Subject: Review of Water Right Application LL-1825

## **Groundwater Application Review Summary Form**

Application # LL- <u>1825</u>

TO:	Water Rights Section	Date6/15/2020	
FROM:	Groundwater Section	Aurora C Bouchier	
		Reviewer's Name	
SUBJECT:	Application LL- <u>1825</u>	Supersedes review ofna

#### Water-Level Trends in Nearby Wells

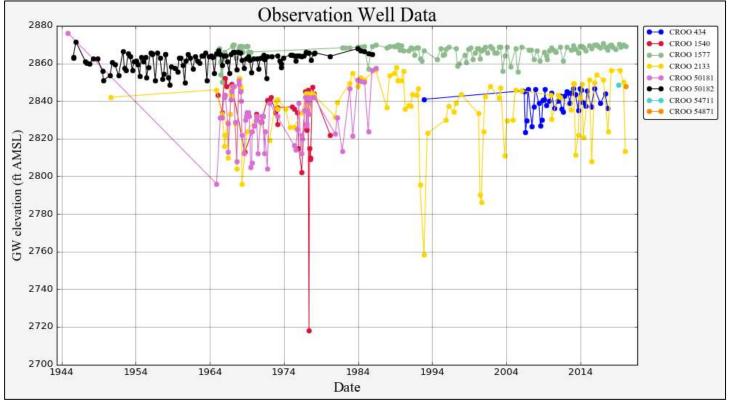
During the 1940's, wells producing from the lower sands and gravels of the fluviolacustrine unit experienced a water level decline which prompted a study by the USGS, resulting in Water-Supply Paper 1619-P which was published in 1963. Since the 1950's-1960's it appears that the water level in wells producing from the lower sands and gravels have remained more or less stable, with spring time water levels essentially coincident with the elevation of the nearby reaches of both Ochoco Creek and the Crooked River (see hydrograph below). This implies a hydraulic connection.

Full Maximum Rate Requested (1200 gpm)

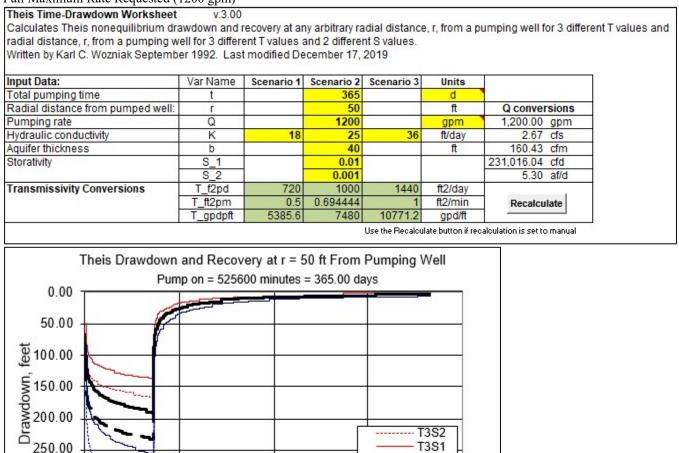
A nearby well (CROO 1540, located approximately 50 feet from the proposed POA) is currently authorized for production of 0.51 cfs under Certificate 94818 (a recent transfer, T-13176, moved 0.26 cfs from CROO 1540 but maintained 0.51 cfs at CROO 1540). Well-to-well interference at CROO 1540 due to pumping at CROO 54871 was modeled using reported transmissivity values for the fluviolacustrine gravels (5,500 to 11,000 gpd/ft, from Robinson and Price) and a 40 foot thick productive zone. At the full requested maximum rate (1200 gpm) the drawdown at CROO 1540 will likely be on the order of 140 to 315 feet (assuming continuous pumping for 365 days). At half the requested maximum rate (600 gpm) the drawdown at CROO 1540 will likely be on the order of 70 to 160 feet (again assuming continuous pumping for 365 days).

Pumping measurements at CROO 1540 list water levels as deep as 217.9 feet below land surface. As CROO 1540 is 256 feet deep, it appears likely that the combined cone of depression if both wells were pumping would be problematic, likely for both wells.
